**CITY OF RAMSEY LAND USE APPLICATION
TECHNICAL REVIEW FILE**

DATE	1/2/2015	PROJECT ADDRESS	7222 SUNWOOD DR NW
PROJECT. TITLE	CASEY'S GENERAL STORE		
ESCROW #	114465		
DEPARTMENT:	Community Development: Planning Division (Comprehensive Plan and Zoning Code)		
TECHNICAL REVIEWER:	Name: Tim Gladhill, Community Development Director Phone: 763-433-9826 Email: tgladhill@cityoframsey.com

DATE	JANUARY 2, 2015	PROJECT ADDRESS	7222 SUNWOOD DRIVE NW
PROJECT. TITLE	CASEY'S STORE PRELIMINARY PLAN REVIEW		
ESCROW #	114465		
DEPARTMENT:	Engineering		
TECHNICAL REVIEWER:	Name: Leonard Linton Phone: 763 433-9834 Email: llinton@cityoframsey.com

We offer the following comments regarding updated plans dated December 3, 2014 prepared by Design Tree Engineering in association with Casey's Construction Division. This review covers the 7 sheets related to the site work.

STANDARD DETAILS
 OIL SKIMMER CATCH
 BASIN

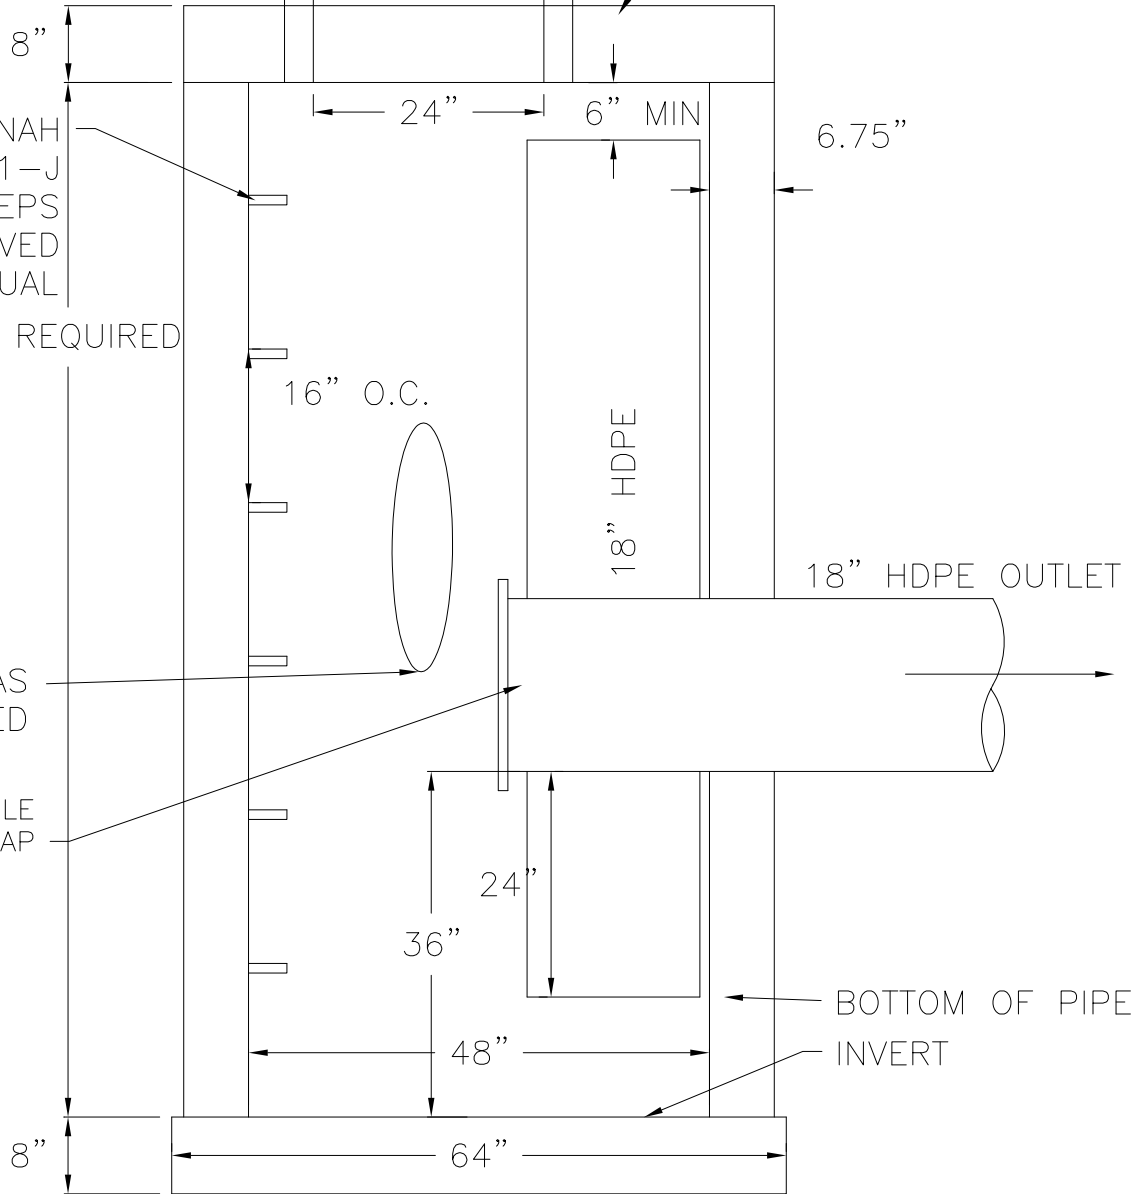
1. Install Oil/Water Separator Manholes upstream of underground stormwater structure.
2. Provide maintenance agreement for Oil/Water Separator Manholes and underground stormwater structure.
3. Obtain Anoka County Highway permit for work in Ramsey Boulevard ROW.
4. Use Inserta Tee device to connect to existing sanitary sewer line. Use trench boxes to protect existing curb. Existing curb and roadway cannot be removed when installing sanitary sewer or watermain.
5. Copper water pipe shall be used between curb stop and existing line.
6. Remove and replace all sidewalk between northern edge of sanitary sewer trench and southern edge of water trench.
7. Use RCP between STMH1 and existing Catch Basin.
8. Adjust existing Catch Basin casting to match flow line. Remove and replace 10 lf of concrete curb adjacent to casting.

STANDARD DETAILS
SILT FENCE

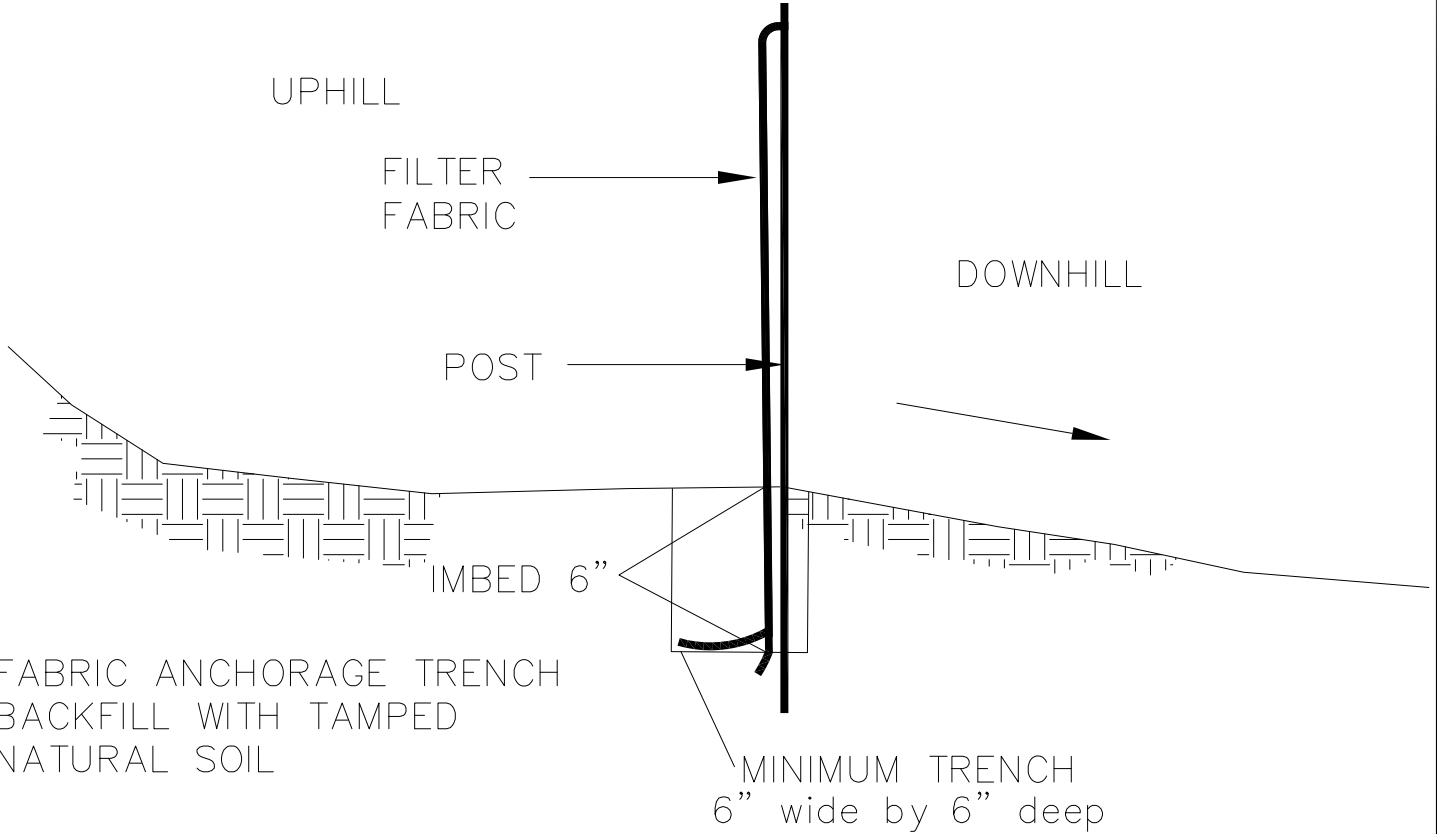
1. Revise details to show silt fence fabric on upslope side of stakes and bottom of fabric placed in 'U' shaped trench backfilled with soil. Refer to City standard detail.

STANDARD DETAILS
 STANDARD DETAILS
 SLAB-TOP MANHOLE

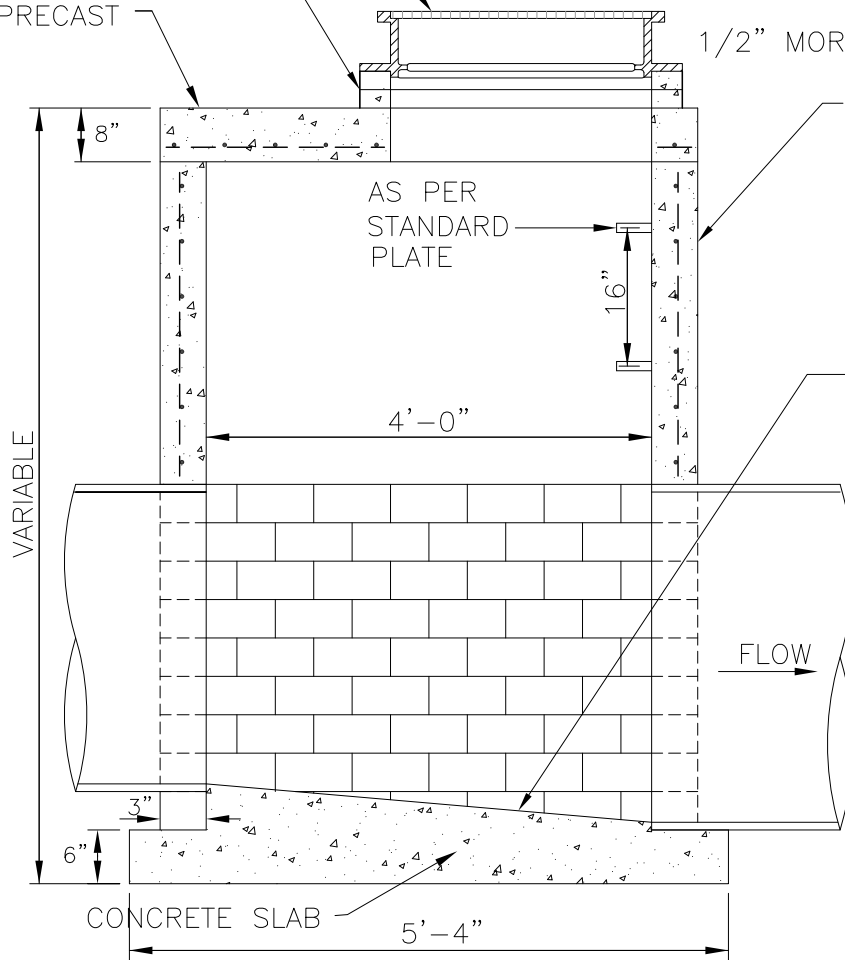
1. Revise Standard Manhole/ Catchbasin Detail as follows:
 - a. Add note: Minimum of 2 and maximum of 6 concrete adjusting rings with mortar.
 - b. Remove note about metal shims.

STANDARD DETAILS
STREET PATCHING
STANDARDS

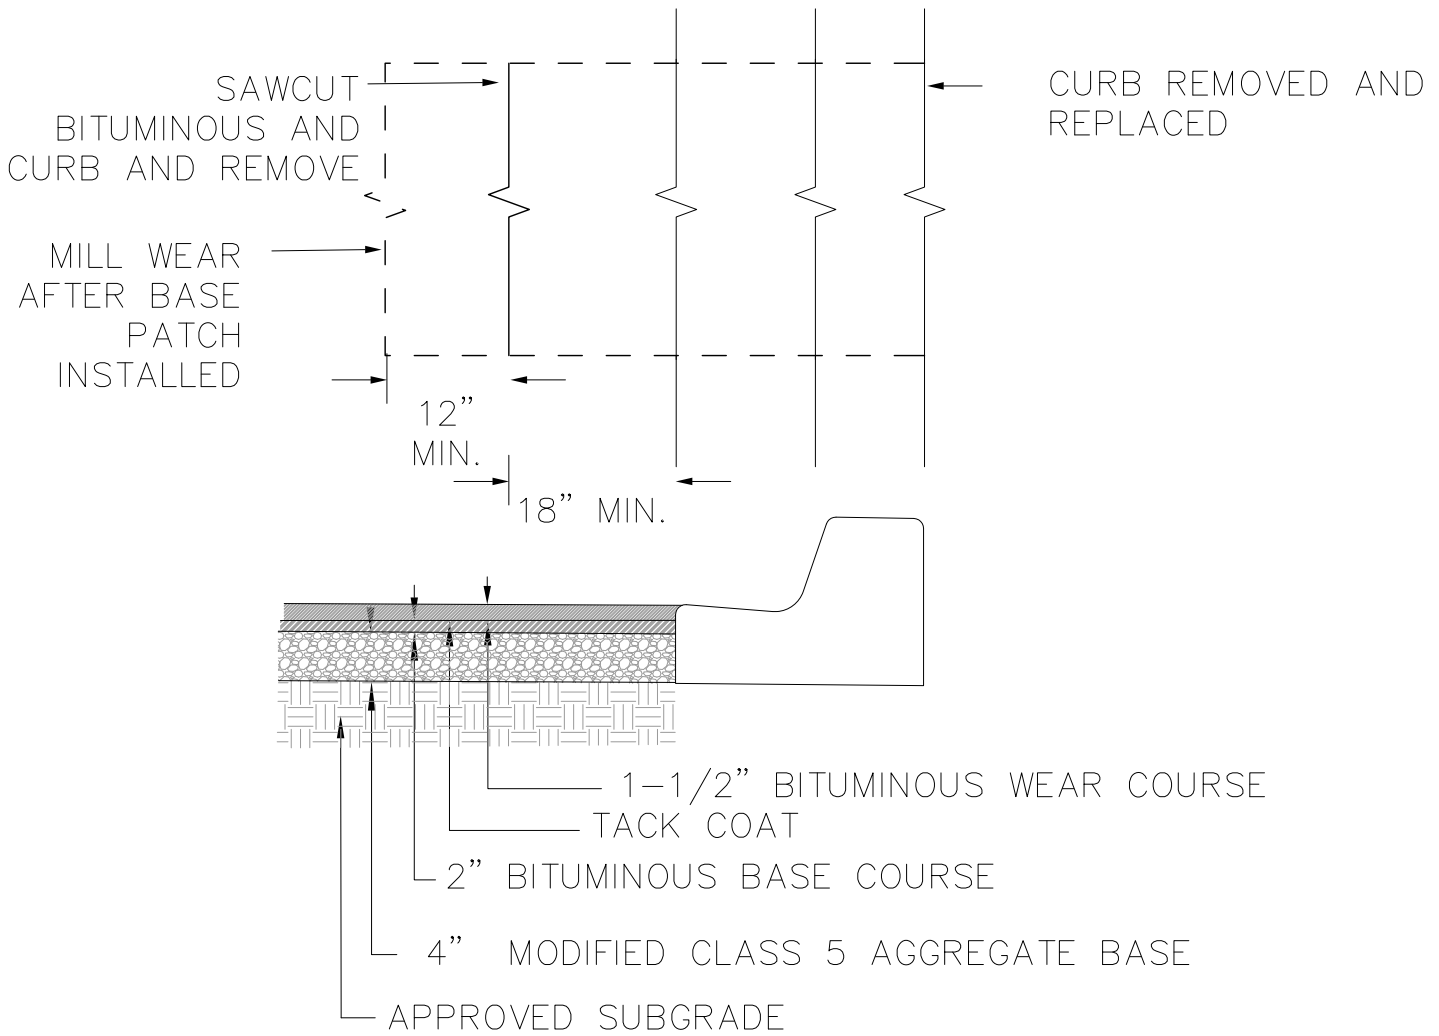
1. Add removal notes for construction of new driveway. Existing curb must be saw cut full depth. Existing bituminous must be saw cut full depth 1 foot from face of curb to be removed. Bituminous wear course must be milled 1 1/2" deep by 12" wide parallel to bituminous removal prior to replacement. Refer to City standard detail.
2. Provide bituminous curb along west edge of driveway.
3. Provide access easements over outlot.
4. Provide encroachment agreement for curb placed in outlot.
5. Install streetscape to match north side of Sunwood drive.
6. Install temporary bituminous trail from west side of access drive to Peridot Street.
7. Identify entity to connect to Sunwood Drive (Note 'G').
